**Service Bulletins
January 1979 to
September 1986 inclusive**

**Rolls-Royce Silver Shadow
Long Wheelbase,
Corniche and Camargue
Bentley T Series and Corniche
Rolls-Royce Silver Shadow II
and Silver Wraith II
Bentley T2**

ALL ROLLS-ROYCE FRANCHISE HOLDERS
SERVICE BULLETIN INDEX FOR TSD 4318

Fig. 2 New Spring

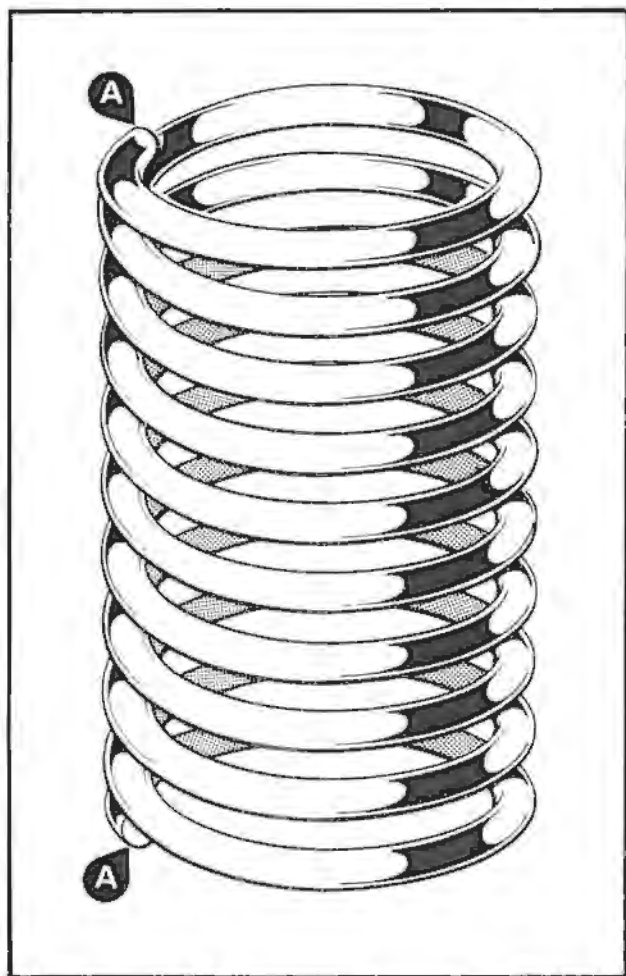
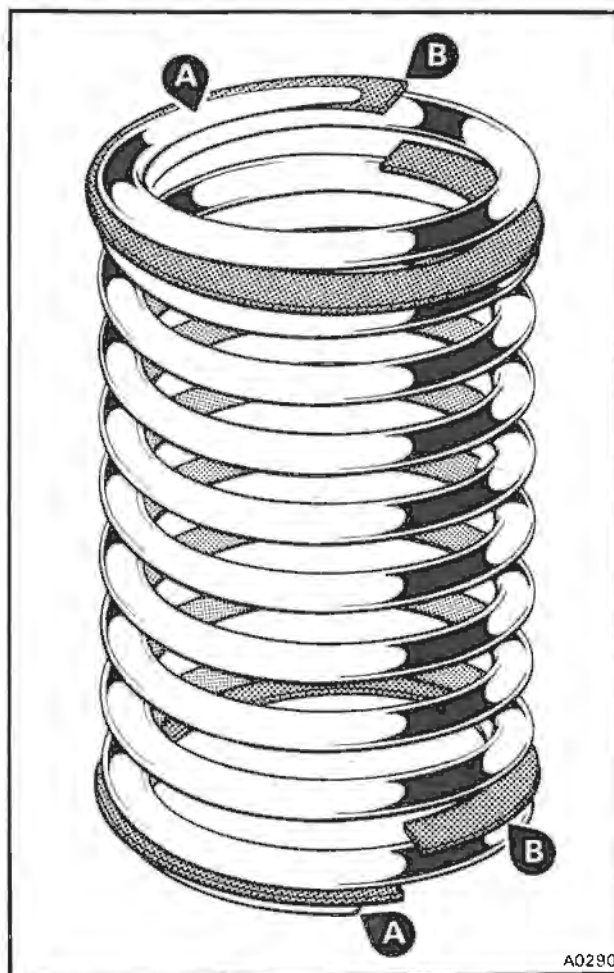
- 4 Place the flexible washers between the first and second coils at each end of the springs (see fig. 3).
- 5 Compress the spring, and refit them to the car.

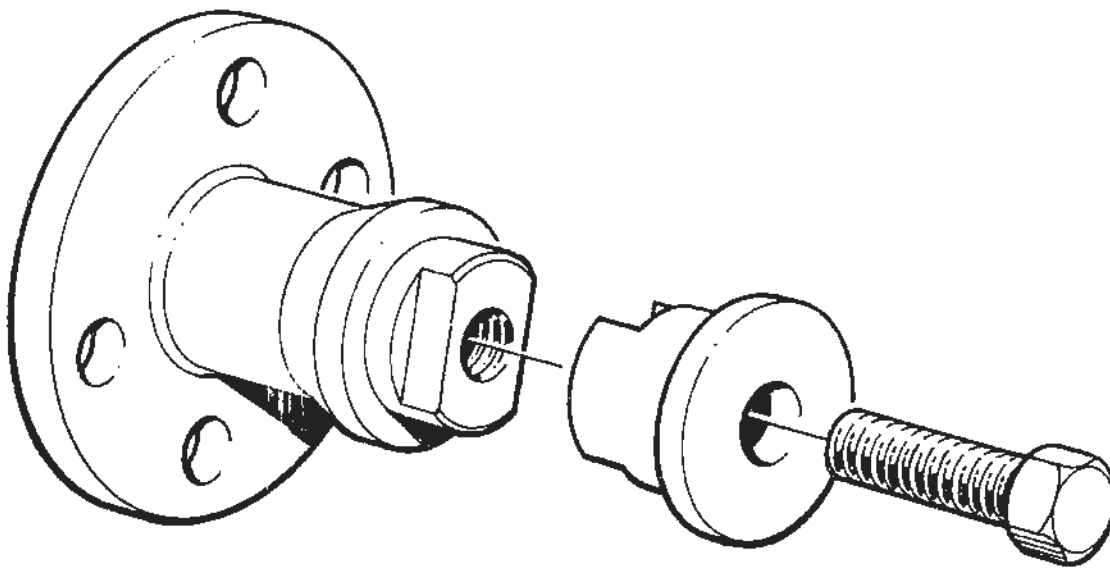
The coolant pump spindle extension piece (UE 40165) and retaining bush (SPC 1800) have been modified to provide a keyed location as shown in Figure 1.

In both the above cases the hexagon headed bolt/hexagonal cap screw should be torque tightened to between 39 Nm and 43 Nm (4,0 kgf m and 4,4 kgf m; 29 lbf ft and 32 lbf ft)

Figure 1. Stop lamp switch adjustment

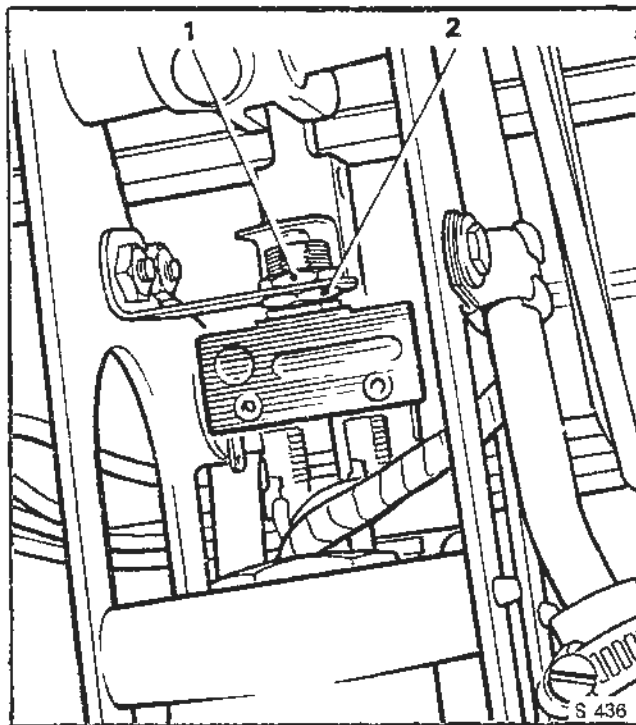
To adjust switch - 0.5 hours.

Fig. 2 Sensor in position

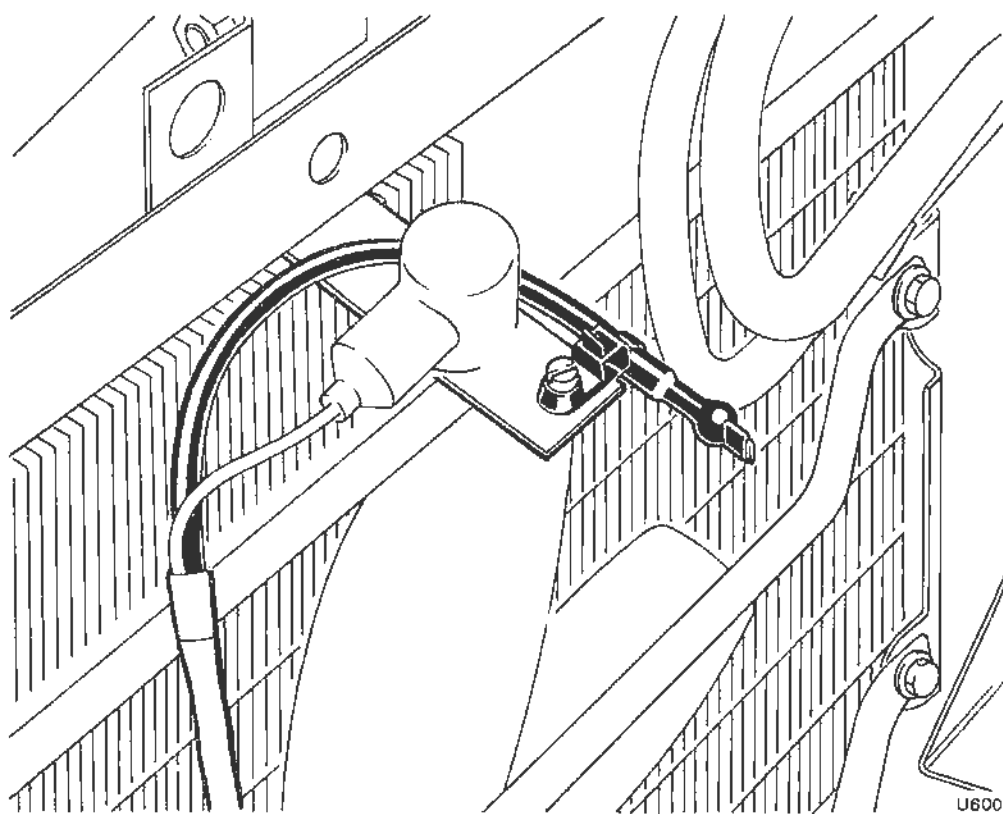
1. Remove the radiator shell.
2. Remove the faulty sensor and connect the 7000 Ω resistance supplied between the 14 slate/white and 14 slate/yellow cables (see Fig. 2).

11. Remove the 7000 Ω resistance and fit the "new type" sensor using the original fixing screw and bracket (see Fig. 2).

FIG 1 - SHOWING THE POSITIONS OF THE CABLES IN THE 3 WAY PLUG AND ALSO THE CORRECT FITTINGS OF THE PROJECTOR SHOE TO THE CARPET.

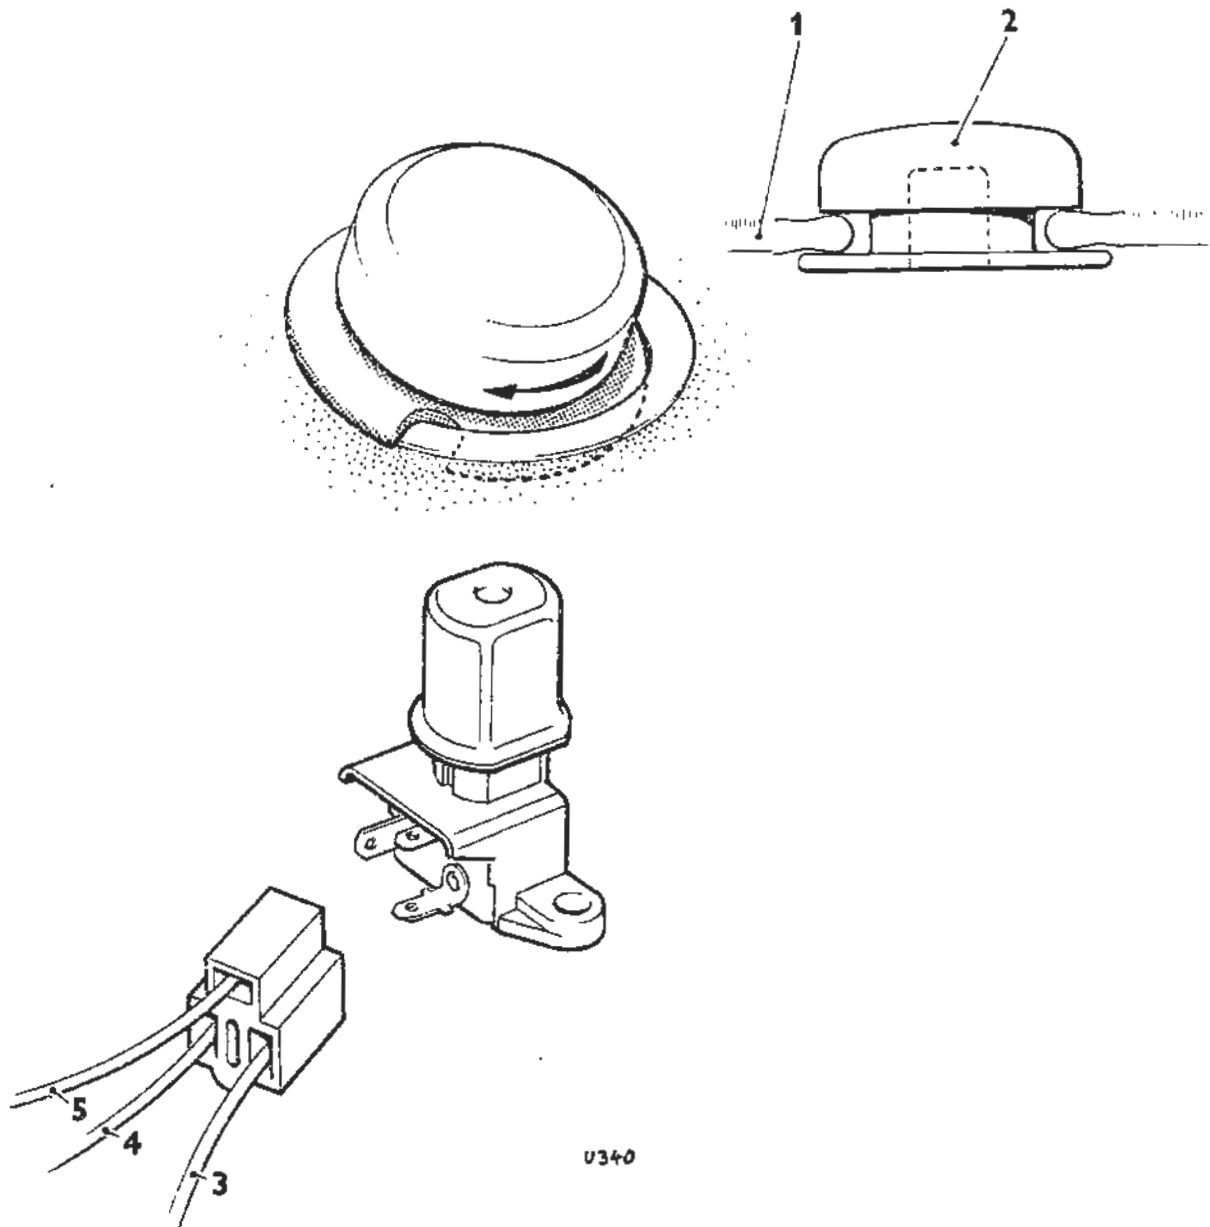
1. Switch the headlights 'on' and operate the dipswitch several times. Check that the headlights operate correctly.
2. Switch the headlights to 'main beam' and remove both 'head safety dip beam' fuses. Check that:
 - a) On cars fitted with halogen headlights that one outer headlight is extinguished.
 - b) On cars fitted with tungsten headlights that all lamps remain illuminated.
3. Replace both 'head safety dipbeam' fuses.
4. If the headlights do not operate as described in operations 1 and 2 check that:
 - a) The wires are connected to the 3 way plug as shown in Figure 1.
 - b) The new type dipswitch is operating correctly.

Fig 1

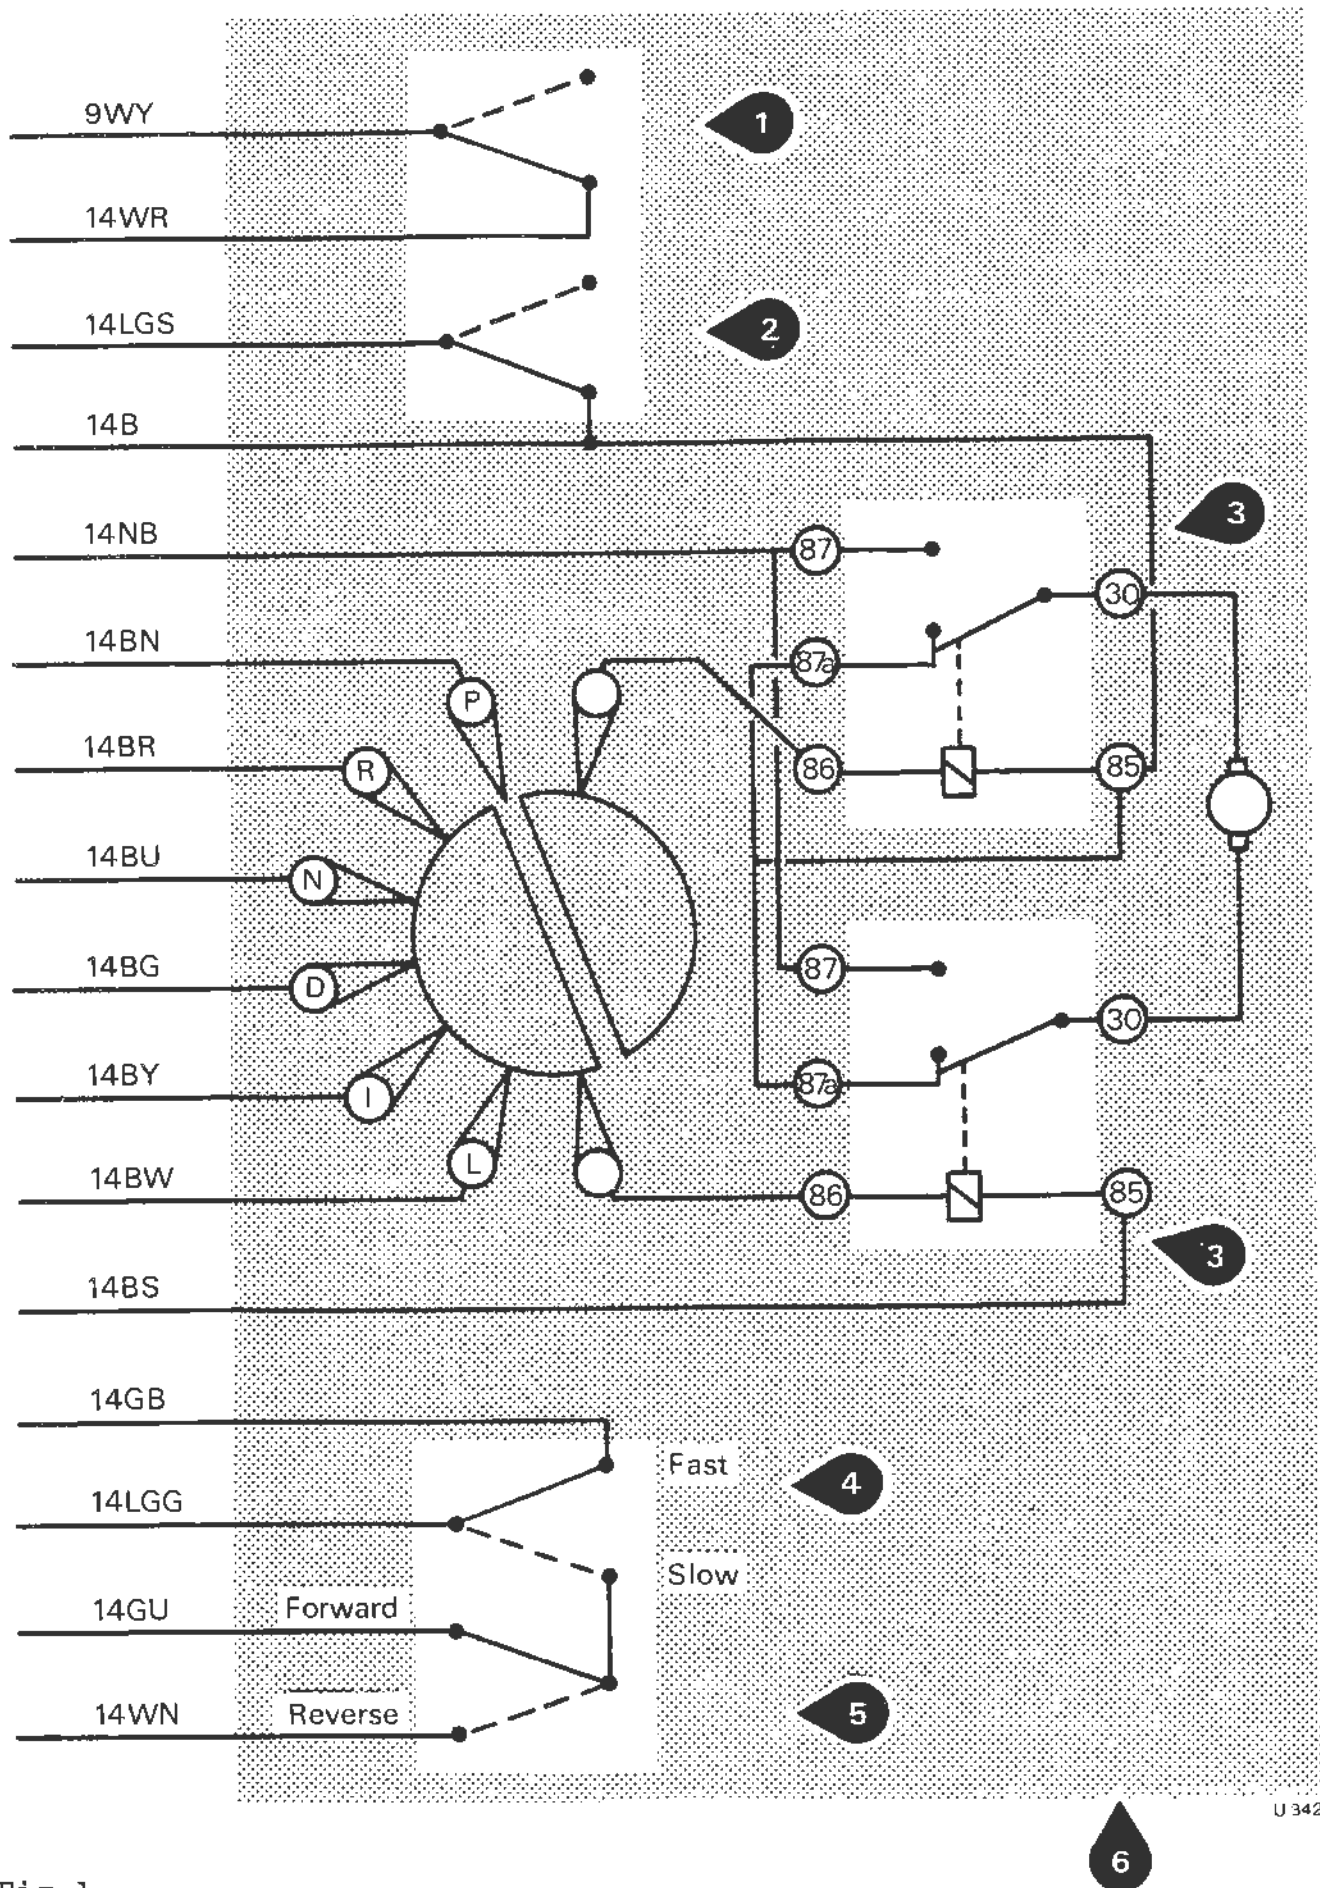
The Lucas Dual Relay part number UG 13111, has been replaced with a pair of Bosch 'mini-relays' part number UD 22452. This has necessitated changes to the wiring of the relays as shown in Figure 1.

FIG. 1

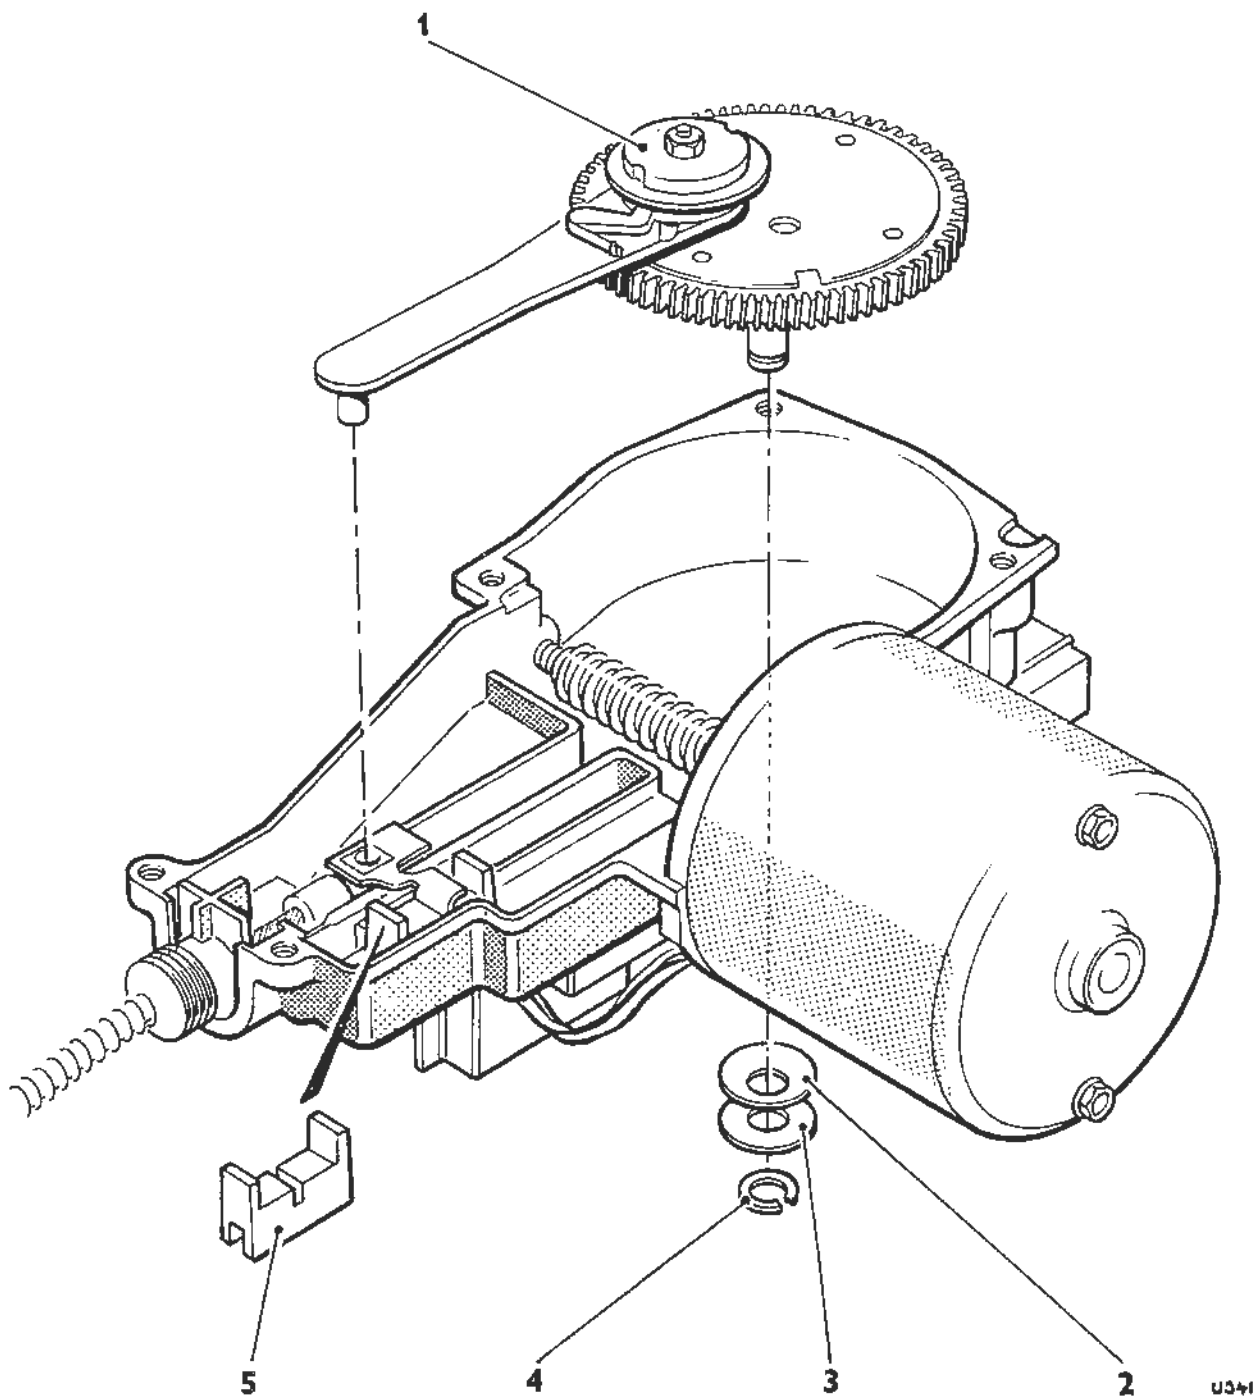
- 2 Fit the new gear and Positive Drive Anti-streak mechanism assembly into the wiper motor, locating the drive rack on the peg of the connecting rod and ensuring that the parking switch slide is fitted to the drive rack and is facing the correct way. This is diagrammatically shown in Figure 1.

Figure 1

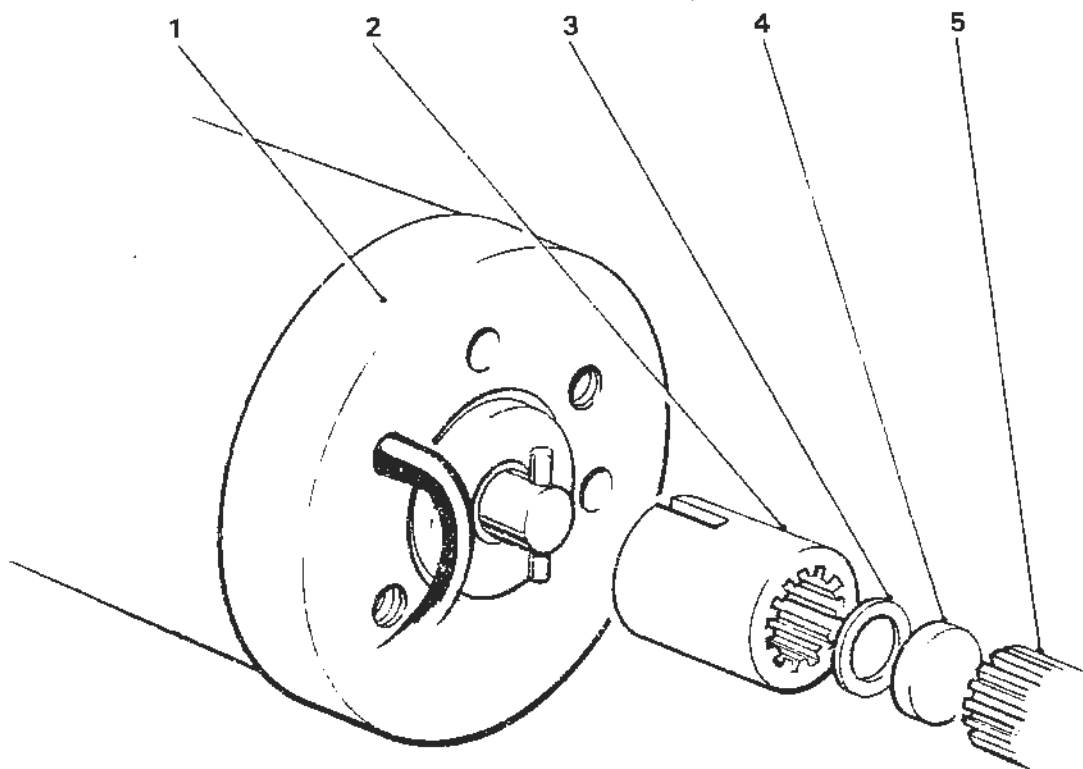
1. Remove the door trim panel.
2. Remove the faulty motor and the splined nylon drive coupling from the window lift unit.
3. From the kit of parts take the new nylon drive coupling and packing washers and assemble as shown in Figure 1. Grease applied to the washers will assist in holding them in position during assembly.
